Subject: Issuance of Amendment No. 6 to Facility Operating License NPF-29 Grand Gulf Nuclear Station, Unit No. 1

GRAND GULF NUCLEAR STATION, UNIT-1

AMENDMENT TO FACILITY OPERATING LICENSE

Amendment No. 6 License No. NPF-29

FIGURE 6.2.2-1 UNIT ORGANIZATION

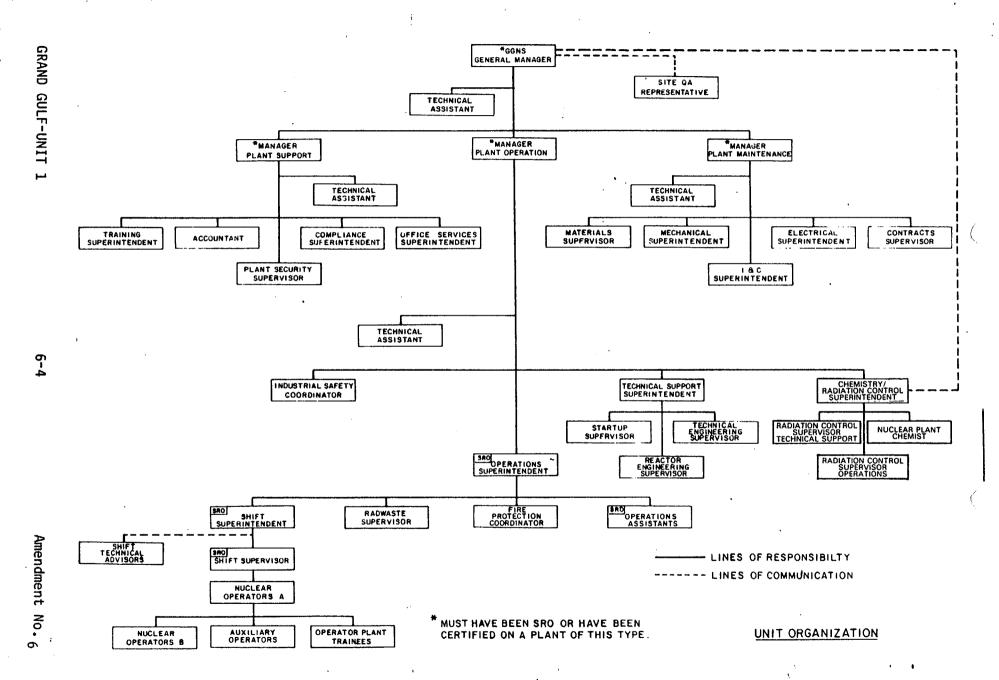
Change (1) would change Section 6.0 "Administrative Controls" of the Technical Specifications. The proposed change takes the responsibilities of the Radiation Control Supervisor shown on Figure 6.2.2-1, Unit Organization, and divides these responsibilities between two new positions of Radiation Control Supervisor-Operations and Radiation Control Supervisor-Technical Support. The Radiation Control Supervisor, Operations would be responsible for radiological aspects of plant maintenance and operations activities. The Radiation Control Supervisor, Technical Support would be responsible for health physics support activities including dosimetry, radwaste, emergency planning, and radiation protection equipment. The staff finds this change acceptable because it does not delete any function currently reporting to the unit General Manager and meets the acceptance criteria of Section 13.1.2 of NUREG-0800 (the Standard Review Plan).
